# Product Change Notification

## 107598 - 00

**Change Notification #:** 107598 - 00  
**Change Title:** Intel Carrier Grade Server TIGW1U, PCN 107598-00, Product Design, Changes to AC Power Distribution Board, Fan Bracket Assembly, DVDCDR, Software Update, SAS OpROM, update PCI-X riser, update Deployment CD, add Battery Isolation.  
**Date of Publication:** Aug 01, 2007

Figure 1. Battery in Relation to PCI Assembly Leg

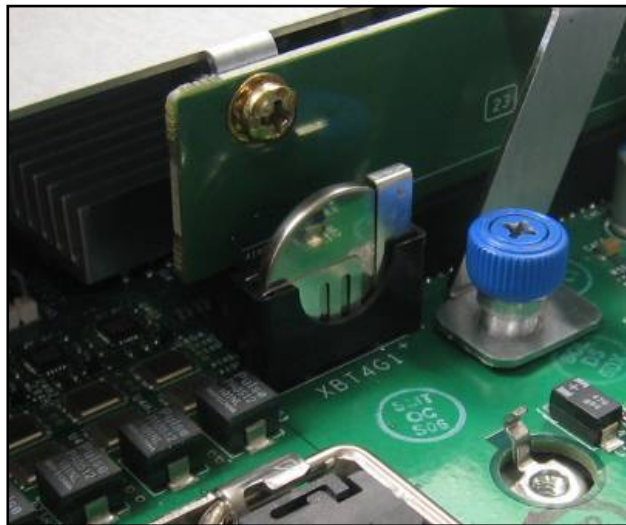
3f. Add battery isolator.

Add battery isolator around battery. As seen in Figure 1, the PCI assembly mechanical assembly is very close to the battery. In order to reduce the chance of the PCI riser card assembly from touching the battery during removal and insertion, a battery isolator is being installed around the battery. Figure 2 shows the battery isolation in place.

Figure 2. Battery Isolation in Place
